TOPIC: PC-23-07 - Peninsula Site Plan Review

BACKGROUND BRIEF: The Peninsula is a site plan request for a 3-unit, single-family, site condominium development located at 160 Darling Drive, Parcel #: 09-02-458-015 - just south of Lake Street and west of S. Park Boulevard. The Project scope includes:

Peninsula Condominiums Site Plan Review

Please see the attached revised site plan documents addressing the review comments from Nowak and Fraus's review letter dated December 14, 2023, Orion Township Fire Department review letter dated December 18, 2023, and Mckenna review letter dated December 19, 2023 (responses are *italicized*):

UTILITY & EASEMENT PLAN THE PENINSULA OF LAKE ORION

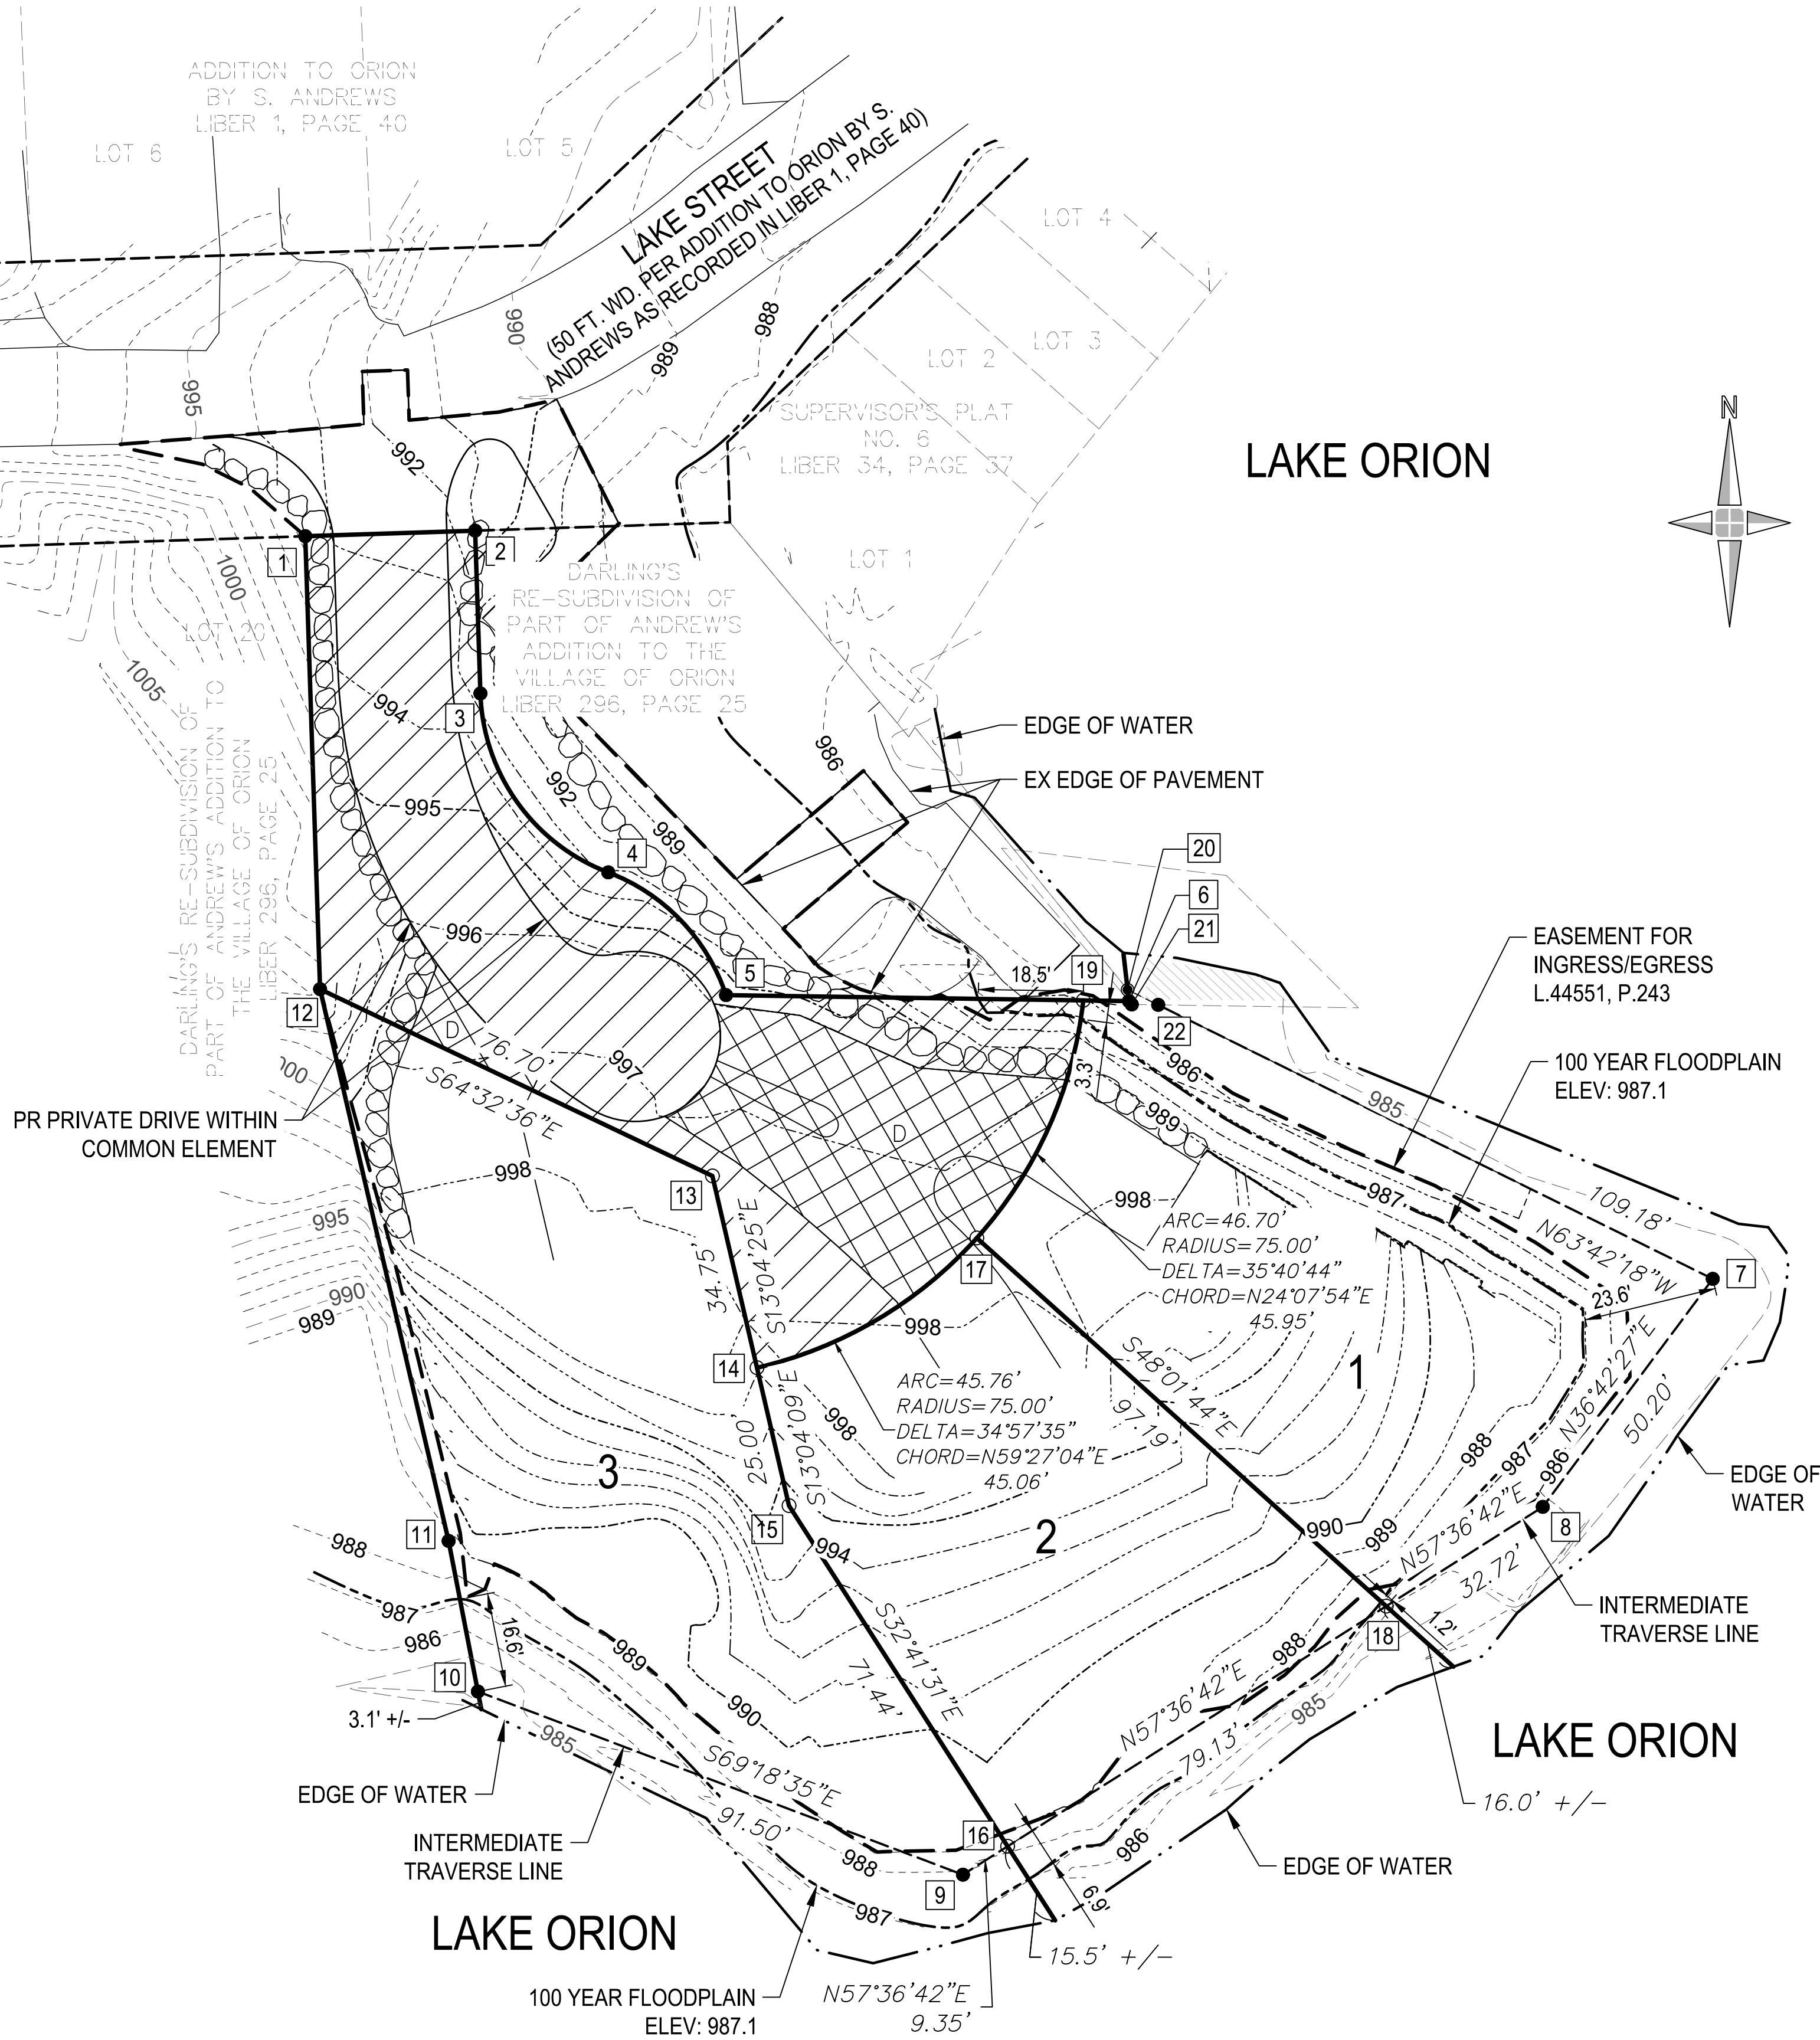
10. Utility service leads are shown but not labeled on the Utility and Easement Plan.
11. Note 3 on sheet 4 of 4 refers to Oakland Township. Correct the reference.
